APPLICANT'S RESPONSES TO ISSUES RAISED AT DEADLINE 6

Drax Bioenergy with Carbon Capture and Storage

Document Reference Number: 8.10.6

PINS Reference: EN010120

APPENDIX 1: NORTHERN SOLUTION LAYOUT (ES FIGURE 2.2 (INDICATIVE PLANT EQUIPMENT LAYOUT))

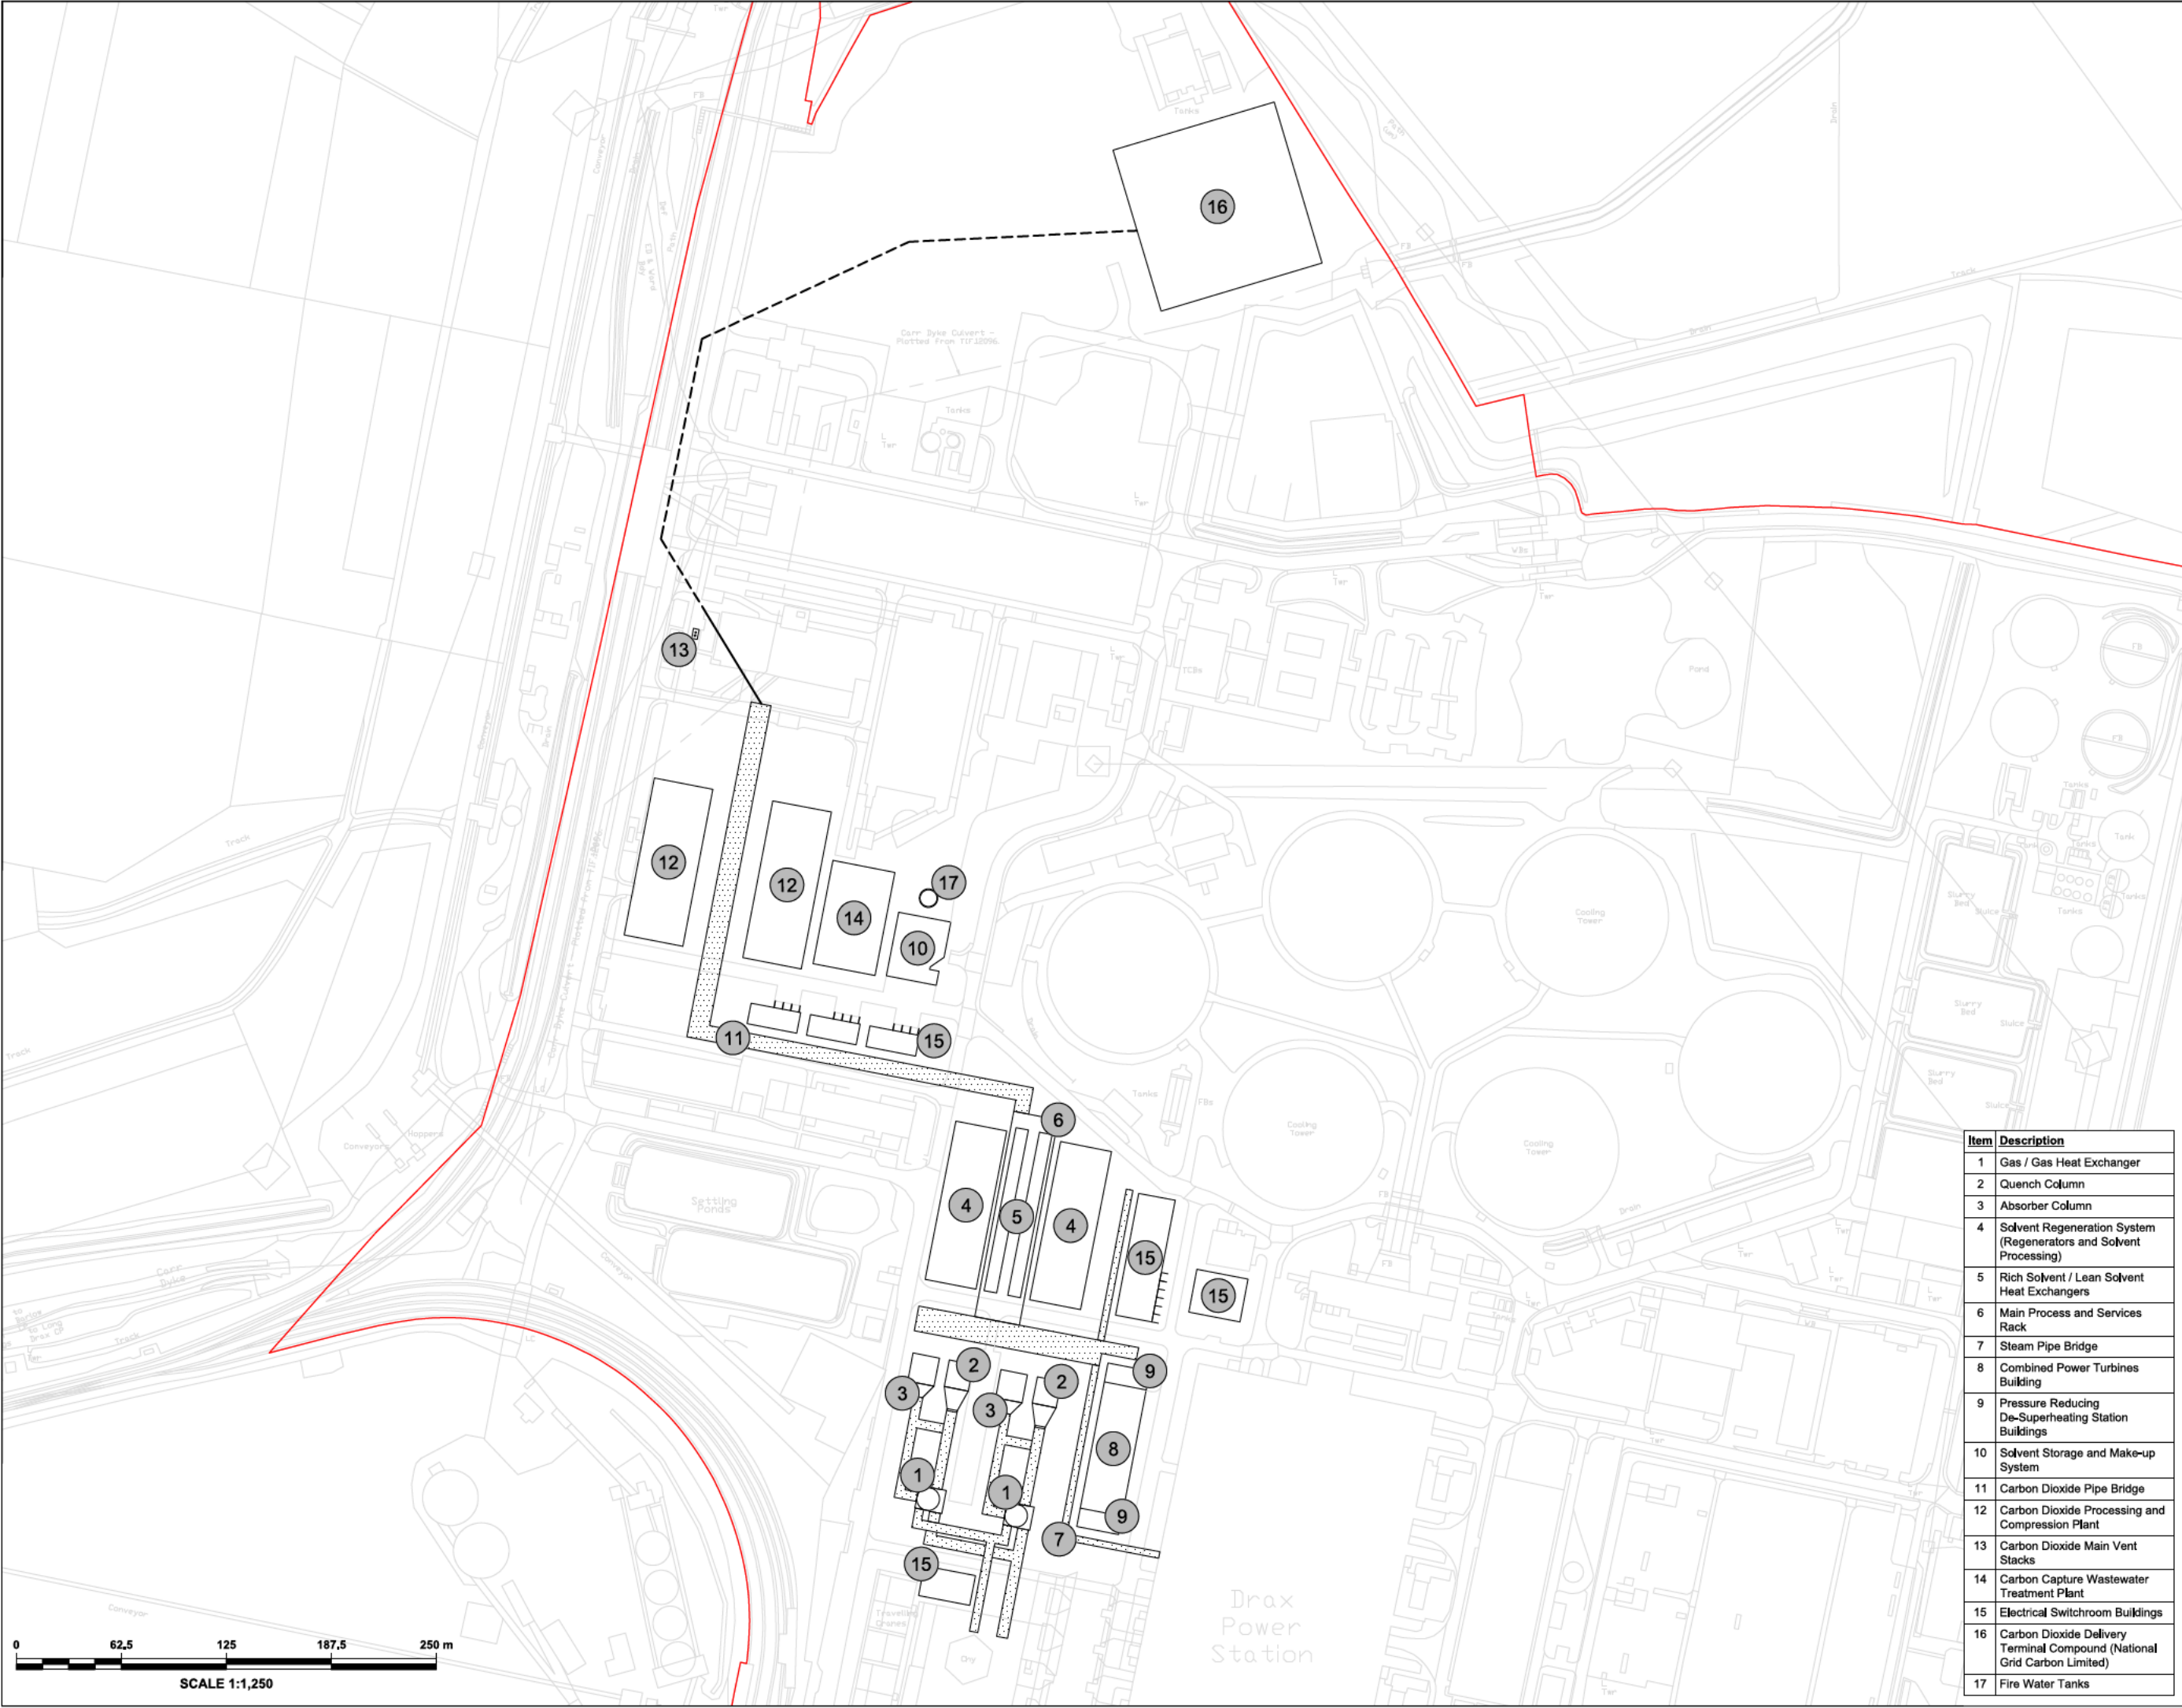
Table 2 shows the distances from the proposed equipment to the residential noise sensitive receptors. The table shows that the shortest distance to noise sensitive receptors is greater in the northern layout compared to the southern layout. The locations of the nearest sensitive receptors are shown in ES Figure 7.3 (Operational Predicted Mitigated Noise Levels) (APP-091), provided in **Appendix 3**.
